HISTORIC AND DESIGN REVIEW COMMISSION

HDRC CASE NO: 2019-458
ADDRESS: 1301 E COMMERCE ST
LEGAL DESCRIPTION: NCB 590 BLK 3 LOT 13, 14 E 60.16' OF 12, & E 183.1' OF 7 & 9
ZONING: AE-1 S, H
CITY COUNCIL DIST.: 2
DISTRICT: Dignowity Hill Historic District
APPLICANT: Alonzo Alston/Sol Studio Architects
OWNER: Store Space
TYPE OF WORK: Exterior modifications
APPLICATION RECEIVED: September 09, 2019
60-DAY REVIEW: November 08, 2019
REQUEST:

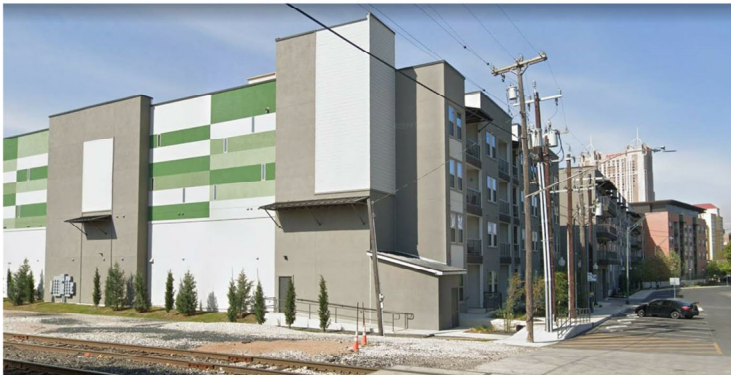
The entrance canopy is cantilevered off the front wall. The canopy is enclosed but water damage is evident at the underside of the soffit. It is likely that the support structure has rusted. The cantilevered canopy is periodically subjected to dynamic wind loading.

The public will access the facility from under this canopy. In our opinion, the canopy poses a significant risk to the public and should be removed.
